**PLANNED UNIT DEVELOPMENT
& SUBDIVISION STAFF REPORT****Date: February 7, 2008****DEVELOPMENT NAME**

Idlewood Village Subdivision

APPLICATION NUMBER 40 & 41 DATE February 7, 2008

DETAIL SITE PLAN

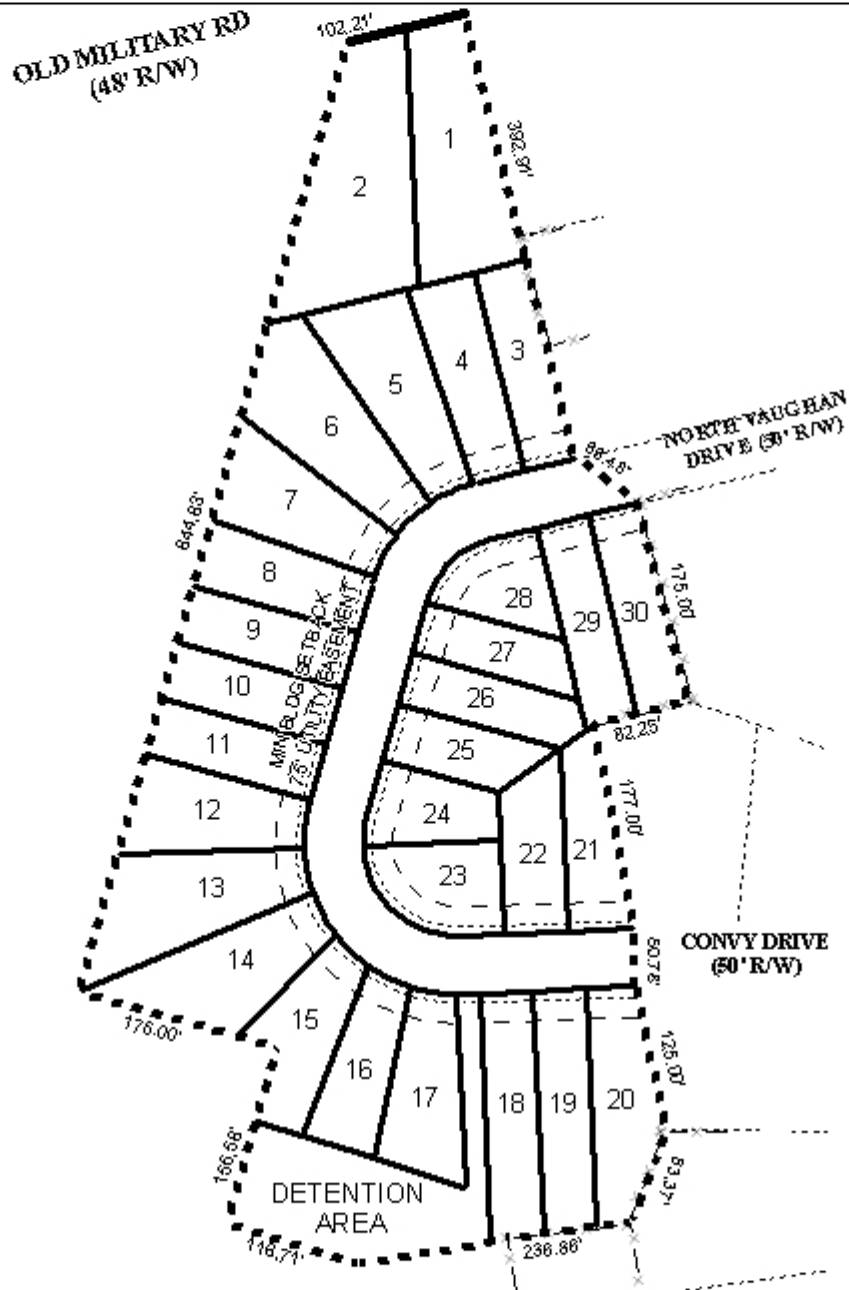
There are two concerns relating to the plan as submitted. The first is that the typical lot layout submitted does not indicate how or where the zero-lot line side will change so that there are no zero-lot lines abutting property which is not located within the proposed development.

The second concern is that of potential access to River Bend Road, a private entrance road to River Bend Condominiums. Several of the lots (2, 6-13) within the proposed subdivision should be denied access to this private drive.

- 1) zero lot line property lines shall be on interior lot, and not adjacent to properties outside the development;
- 2) no two zero lot property lines to be adjacent to one another;

- 3) labeling of all common areas, and placement of a note on the site plan and plat stating that maintenance of common and detention common areas is the responsibility of the property owners;

- 4) placement of a note on the site plan and plat that lots 2, & 6-13 are denied direct access to River Bend Condominium private drive;
- 5) placement of a note on the site plan and plat that each lot is limited to one curb-cut, with the size, design and location to be coordinated with Urban Forestry, and approved by Traffic Engineering and in compliance with AASHTO standards;
